Item ID: D412-664-203

Item Name: Crosstube Aft

DRAWING NO. D412-664-243	TITLE CROSSTUBE ASS'Y (412 HI AFT)	REV. E	DART AEROSPACE LTD ENGINEERING ORDER		D.E.O. NO. D412-664-243-E-2	SHEET NO. SHEET 1 OF 1	SCALE NTS
DRAWN <i>MP</i>	CHECKED <i>ASS</i>	MFG. APPR. <i>RE</i>	APPROVED <i>MP</i>		DE APPR. <i>TH</i>		
DATE 11.09.07	DATE 11.09.19	DATE 11.09.19	DATE 11.09.19		DATE 11.09.19

DRAWING NO. D412-664-243	TITLE CROSSTUBE ASSEMBLY (412 HI AFT)	REV. E	DART AEROSPACE LTD ENGINEERING ORDER		D.E.O. NO. D412-664-243-E-4	SHEET NO. SHEET 1 OF 3	SCALE NTS
DRAWN 92	CHECKED A	MFG. APPR. A	APPROVED MP		DE APPR. MP		
DATE 12.08.21	DATE 12.08.30	DATE 12.08.30	DATE 12/8/30		DATE 12.08.30

**D412-664-243
ASSEMBLY DETAIL**

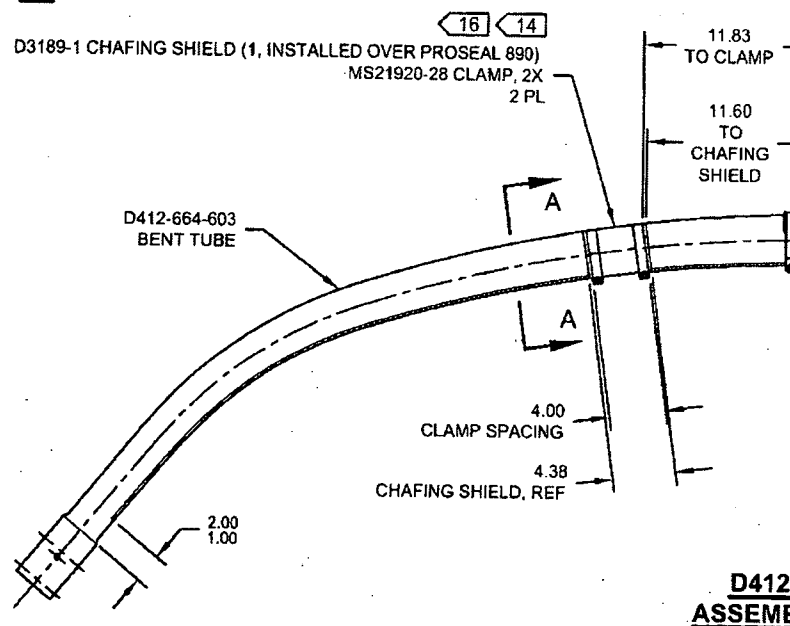
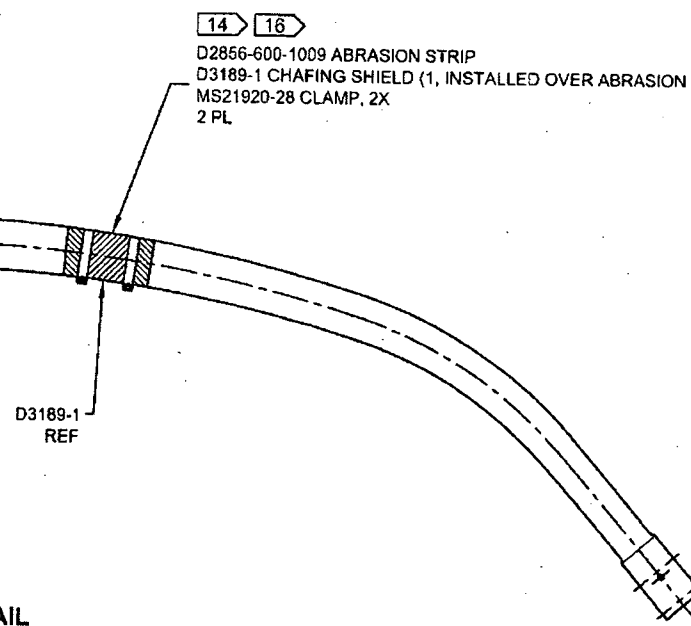
REMOVED ABRASION STRIP IN FAVOR OF A THIN LAYER OF PROSEAL 890. UPDATE INSTALLATION OF CHAFING SHIELDS AND REDUCE TORQUE TO 40-50 IN-LBS. THIS ENGINEERING ORDER SUPERCEDES DEO D412-664-243-E-1.

D3189-1 CHAFING SHIELD (1, INSTALLED OVER PROSEAL 890)
MS21920-28 CLAMP, 2X
2 PL

D2856-600-1009 ABRASION STRIP
D3189-1 CHAFING SHIELD (1, INSTALLED OVER ABRASION STRIP)
MS21920-28 CLAMP, 2X
2 PL
